Mechanical Addendum M-001

Date: June 19, 2026
Project: Ontario Aboriginal Housing Services
Location: 321 John Street, Cobourg, Ontario
IVES Project: 22071

M-301A

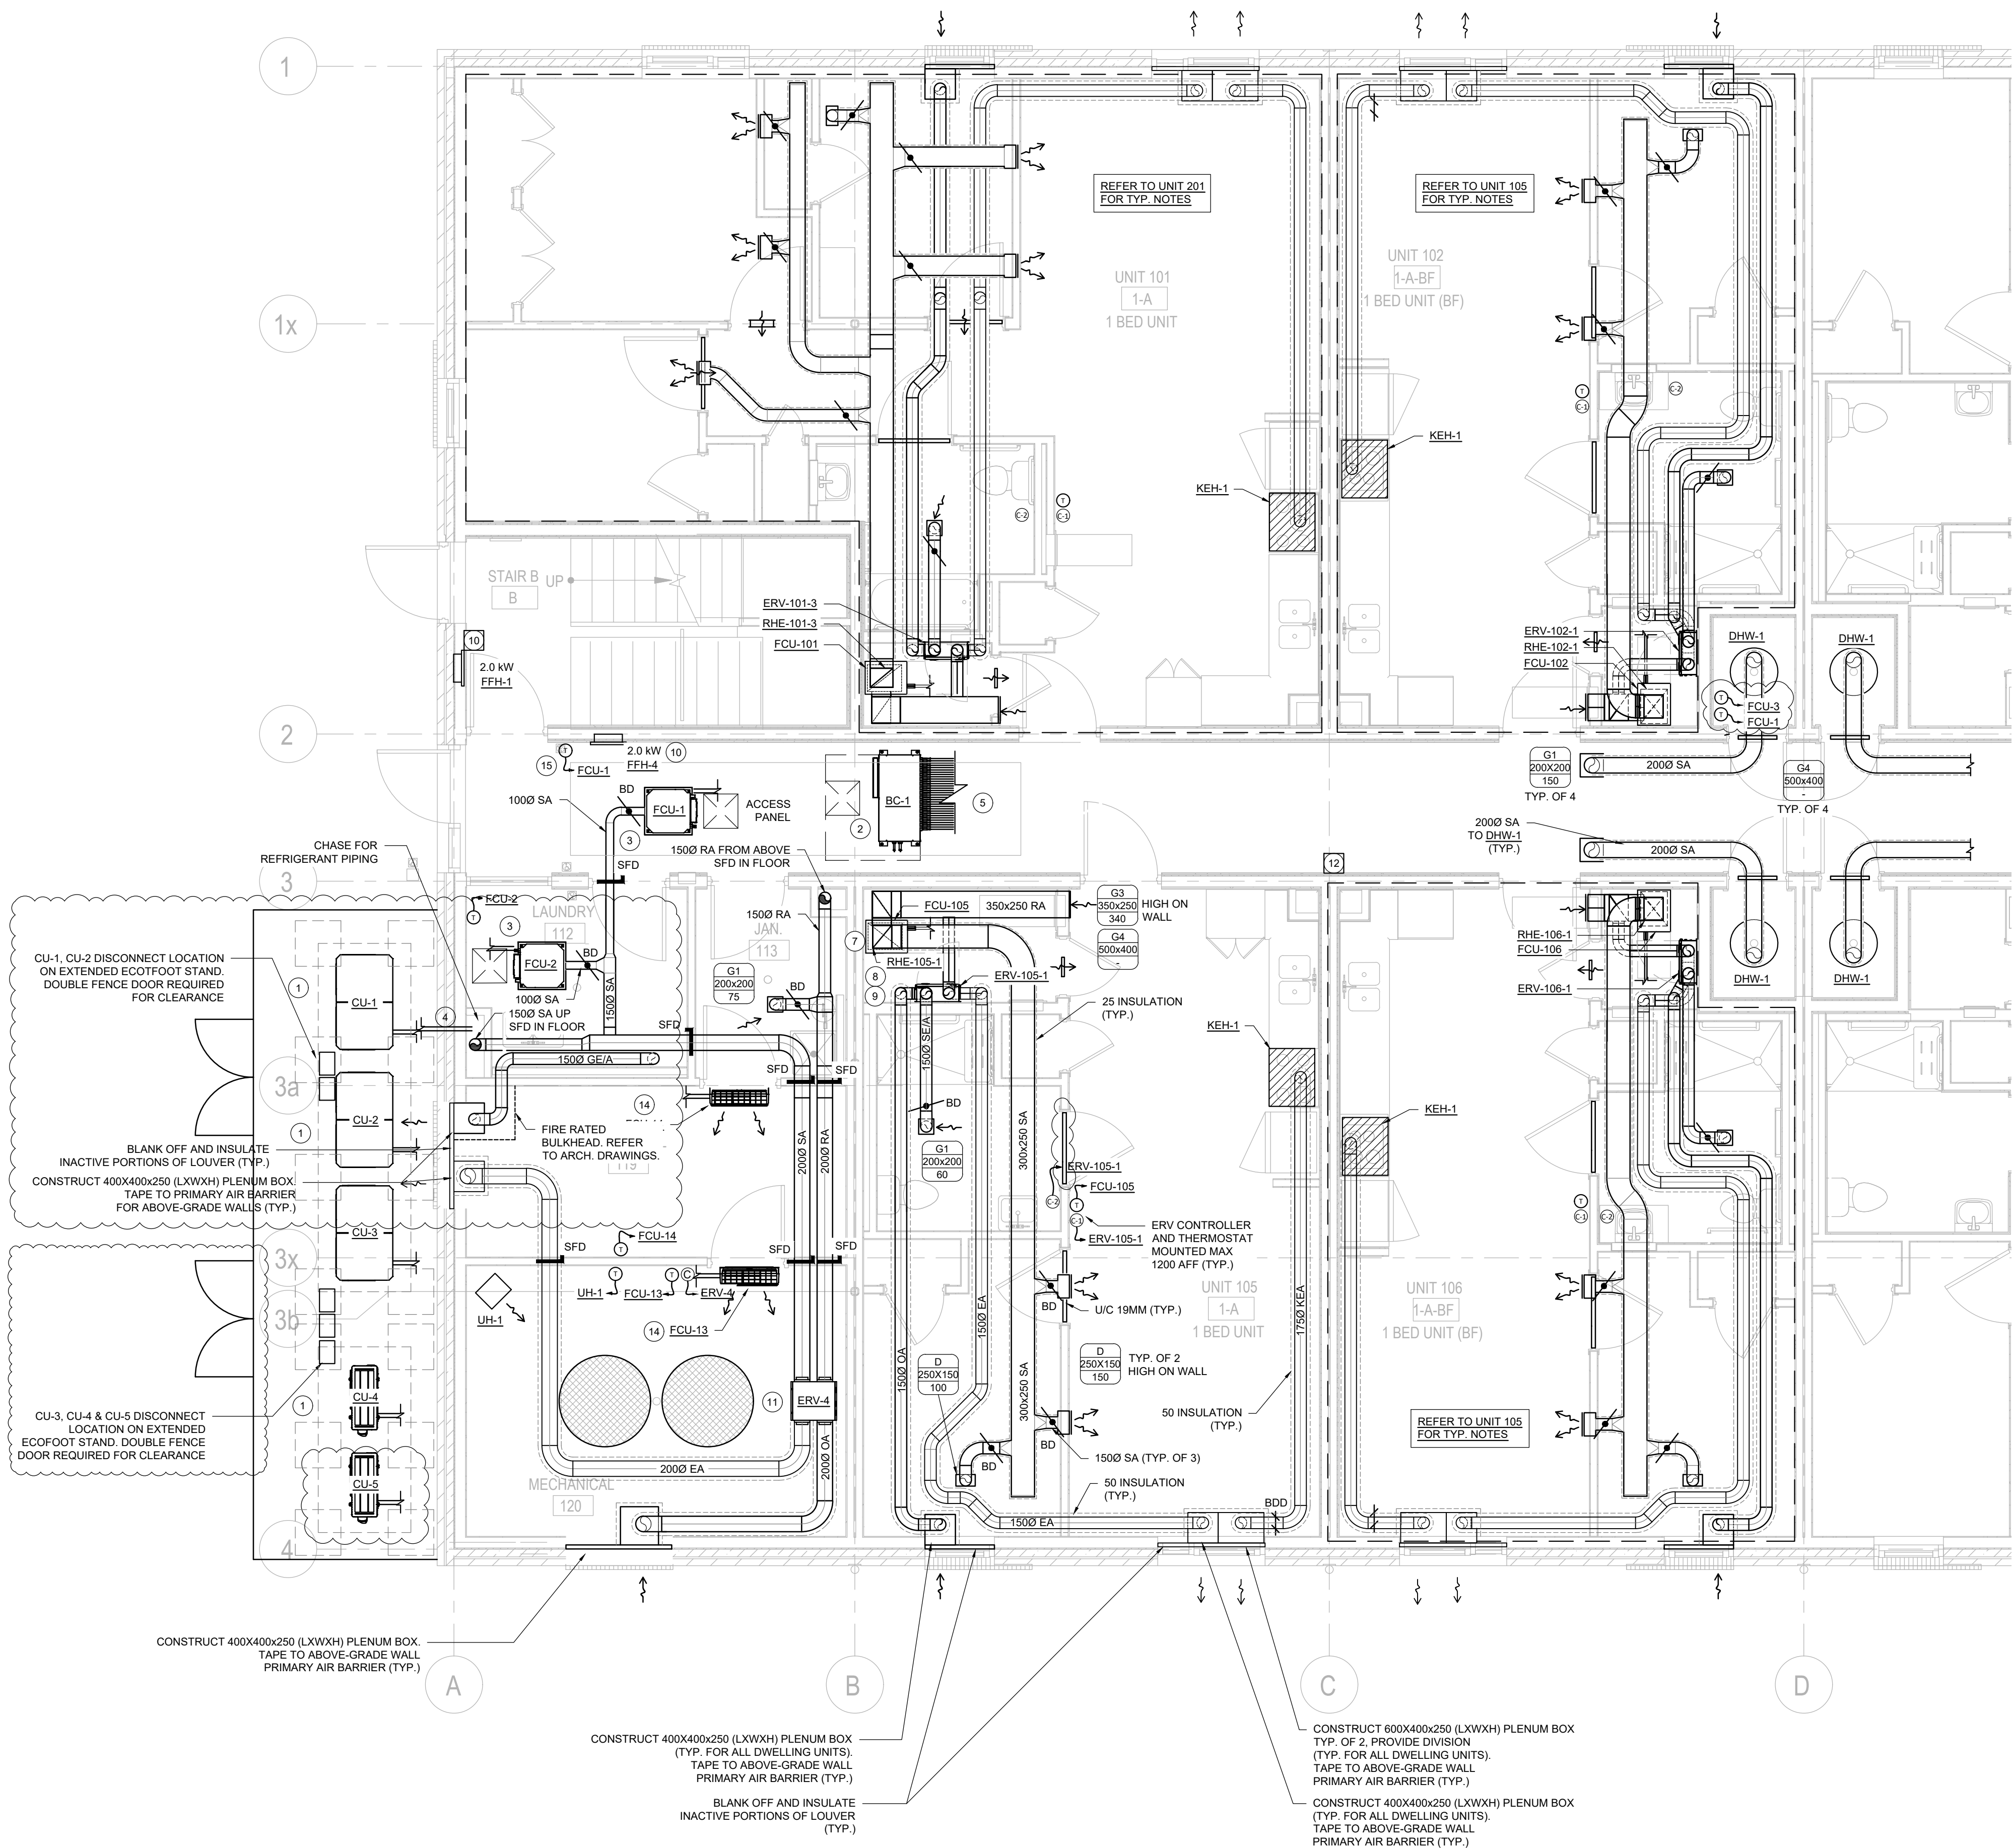
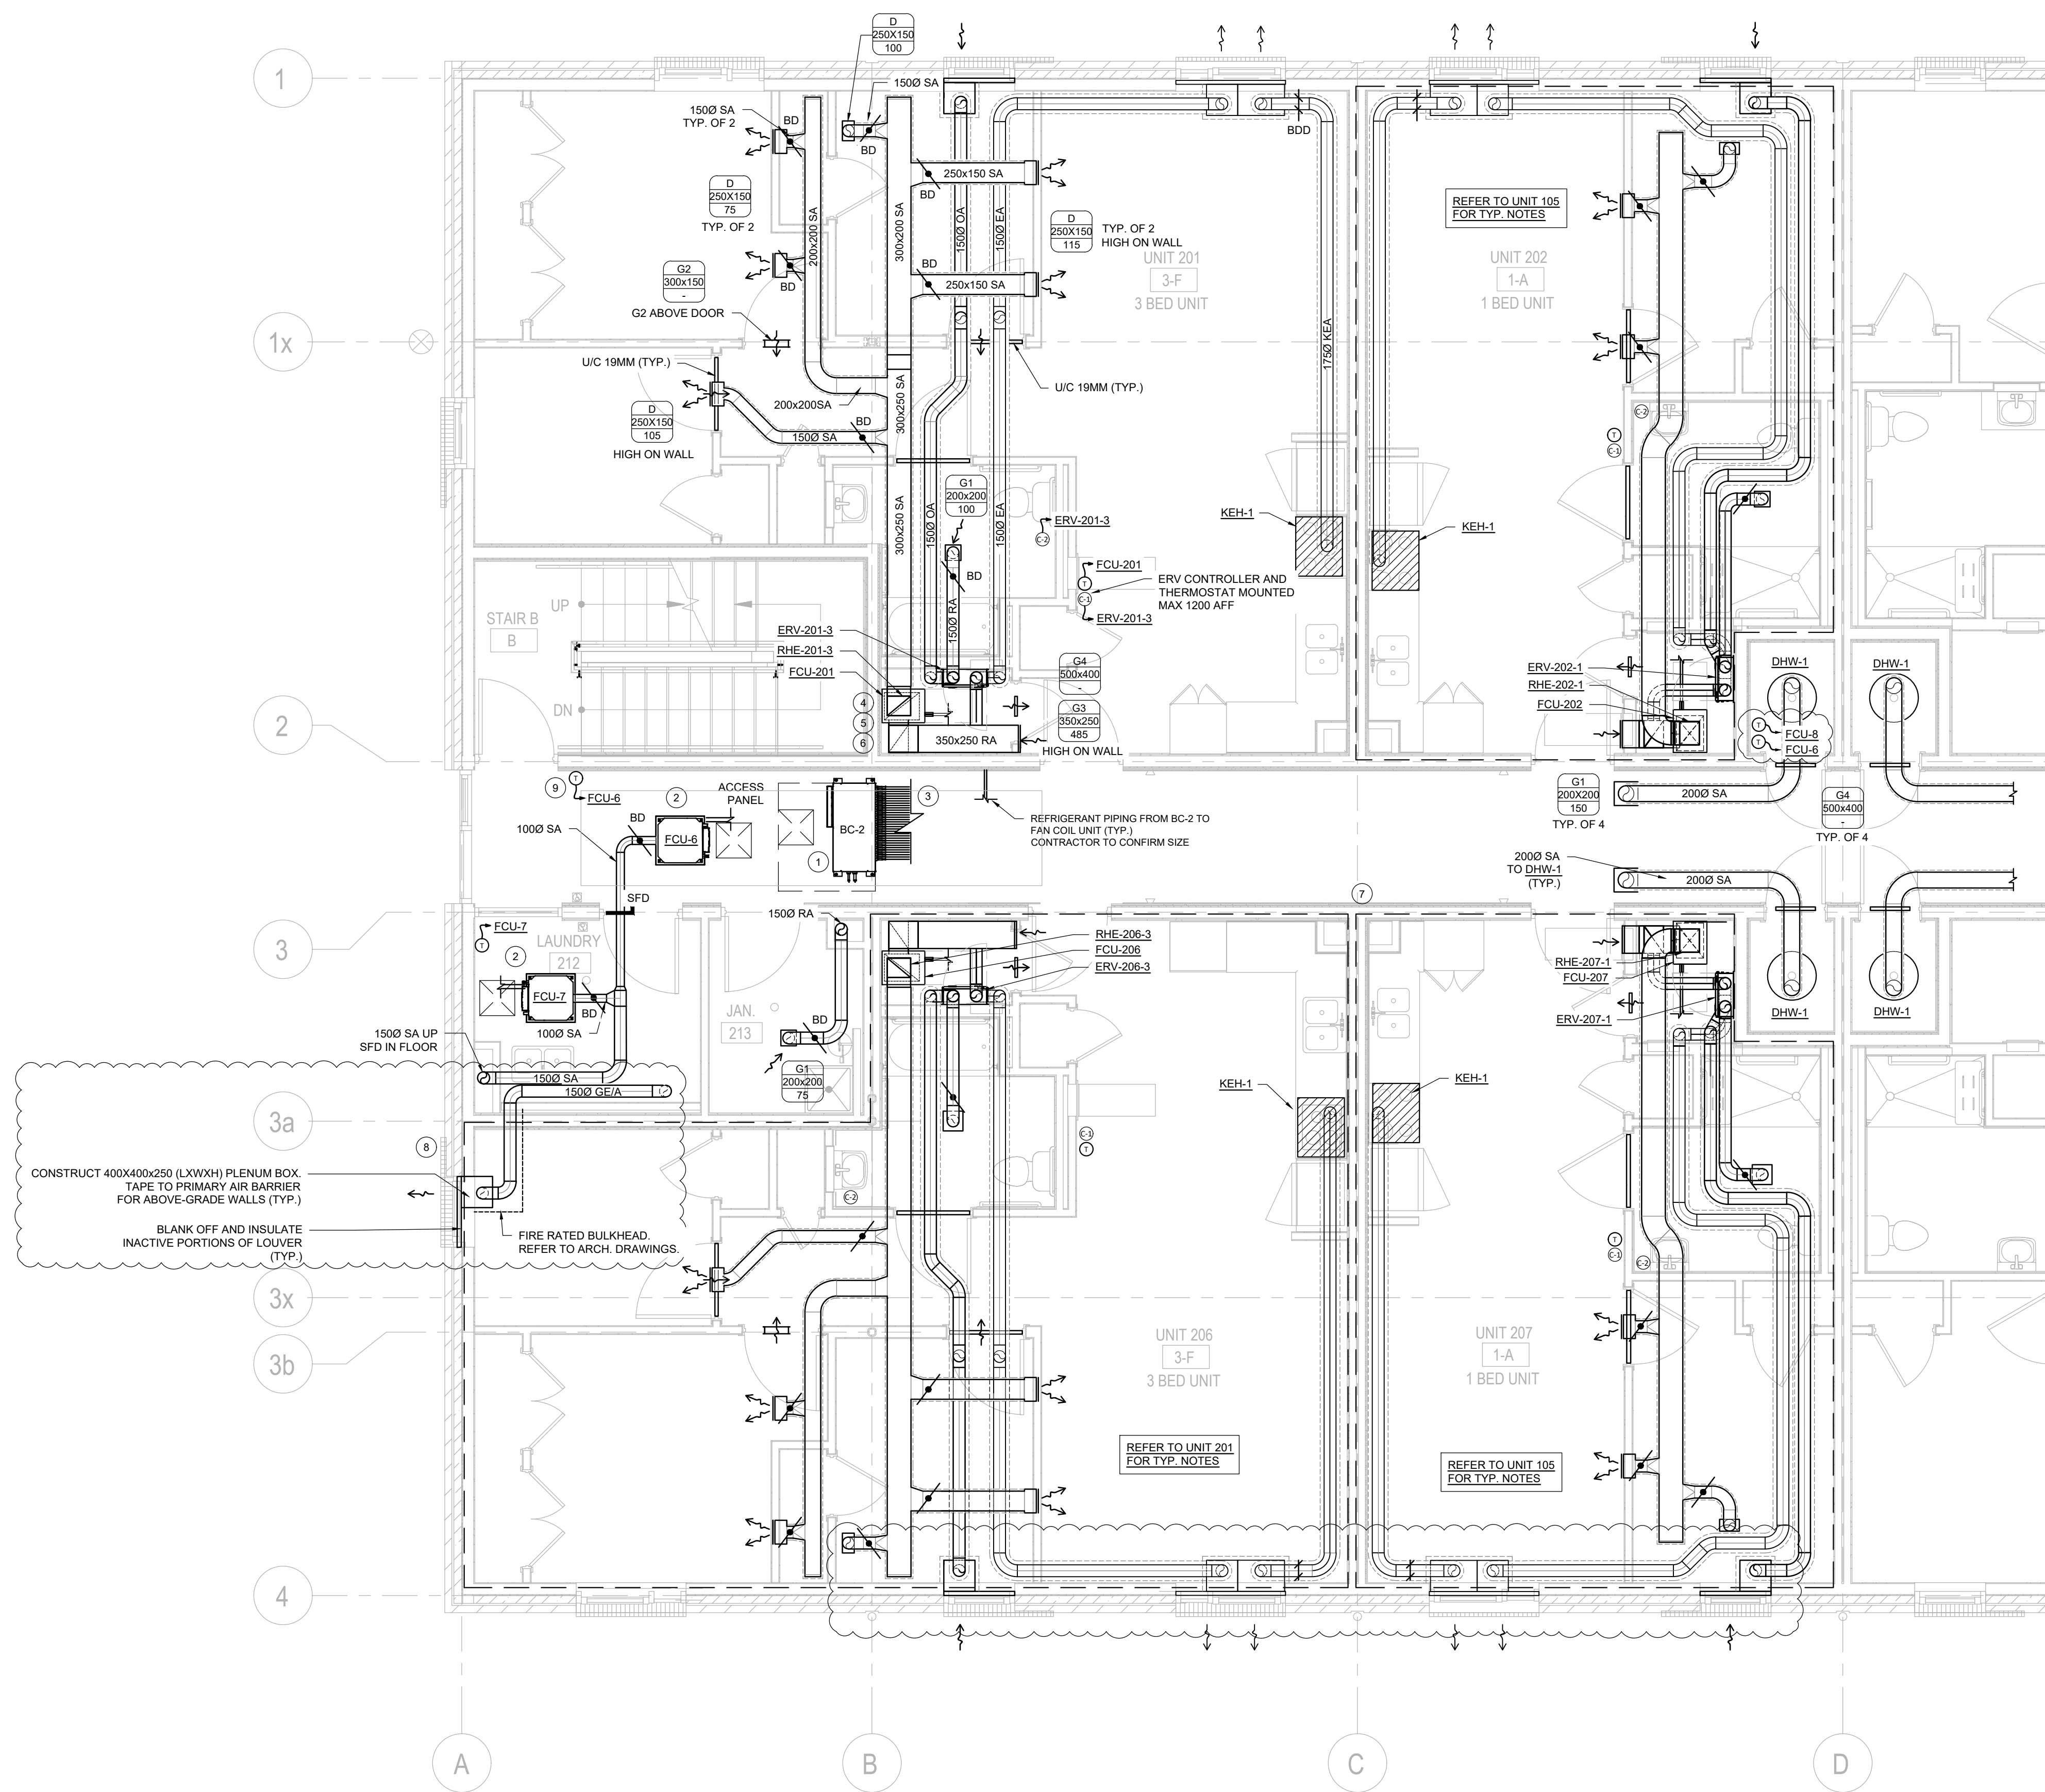
- 1.10. Refer to Mechanical Drawing M-301A – Ground Floor West HVAC Plan (Re-issued)
 - 1.10.1. Revised as indicated.
- 1.11. Refer to Mechanical Drawing M-301B – Ground Floor East HVAC Plan (Re-issued)
